Dear Valued Blum Customer,

The Blum hinge and mounting plate you currently have are now discontinued/obsolete. Please refer to the illustrations below to determine the necessary modifications for your door and frame, based on the hinge and the style of mounting plate you currently have.

COMPACT 31

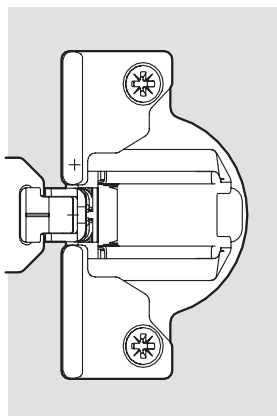
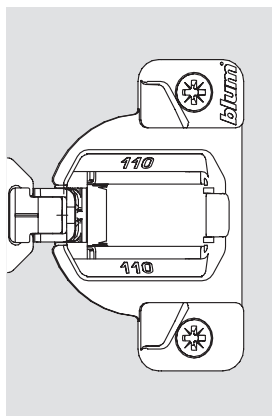
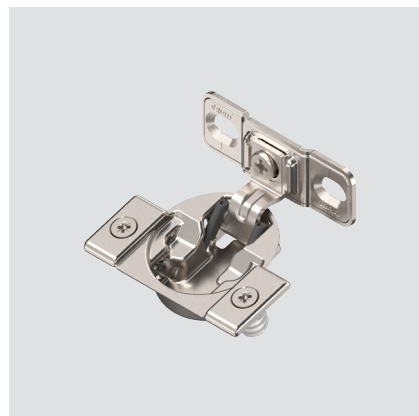
***COMPACT 31 -**
See steps below for
door side replacement
before page 2

COMPACT 33 -
Skip the steps below and
proceed to page 2

COMPACT 38B

COMPACT 31 replacement (door side)

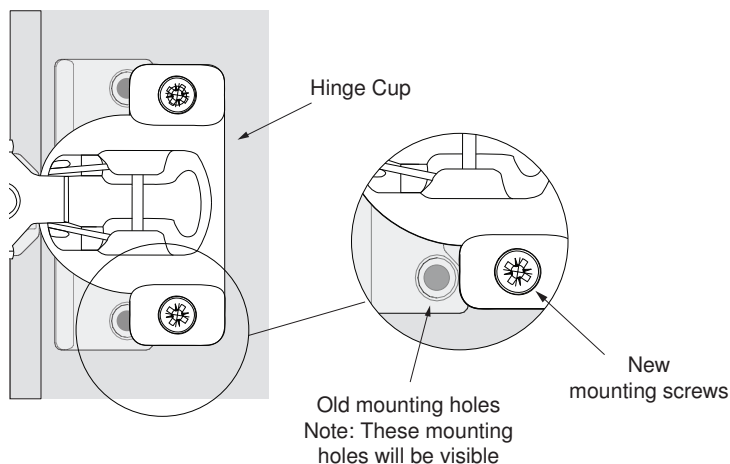
When replacing a COMPACT 31, the direction of the hinge cup is rotated and the previous mounting holes will still be visible as shown below.

- For the hinge cup, you will need **#6 x 5/8 wood screws**

Obsolete mounting plates (cabinet side)

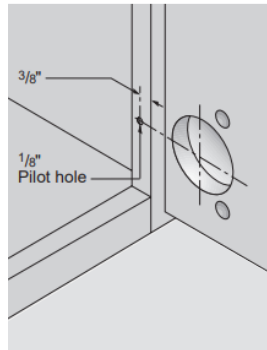
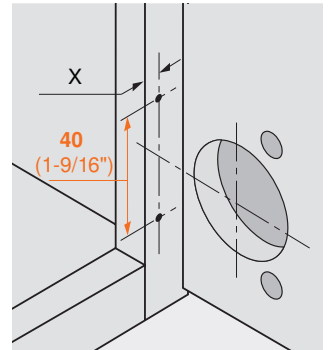
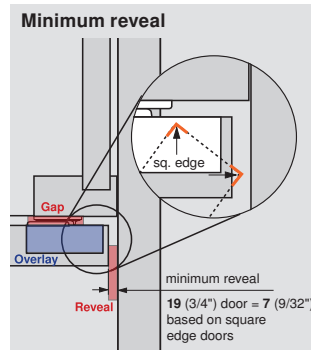
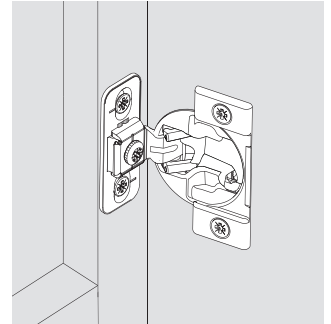
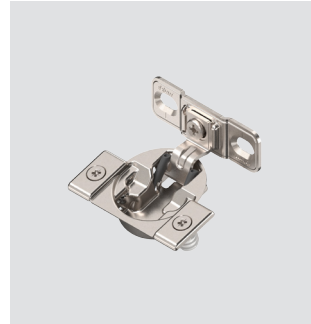
If your mounting plate is either showing the numbers **130.116-01** or **130.216-01** (see above), you have a **1-5/8"** overlay.

Current replacement 38B

Overlay (OL)	X
41 (1-5/8")	15 (19/32")
For any other overlays, use formula: $X = OL - 35 (1-3/8") + 9 (11/32")$

133.024-01

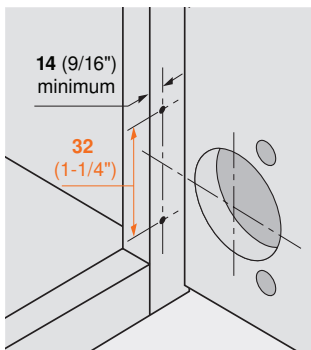
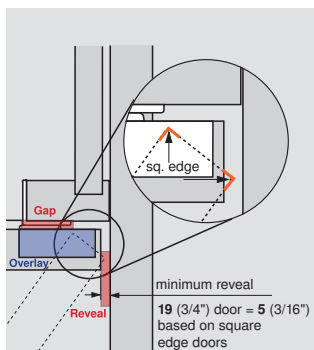
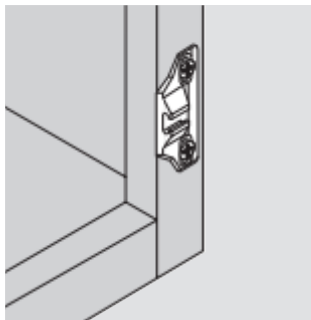
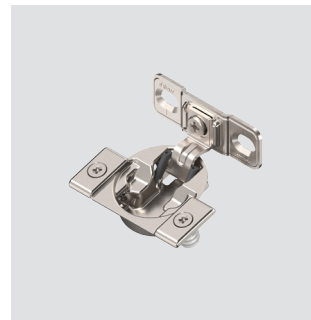
- Increase screw hole spacing to **40 (1-9/16")** on the new plate (previously **32 (1-1/4")**)
- Each screw hole shifts **4 (1/4")** outward from the cup hole centerline
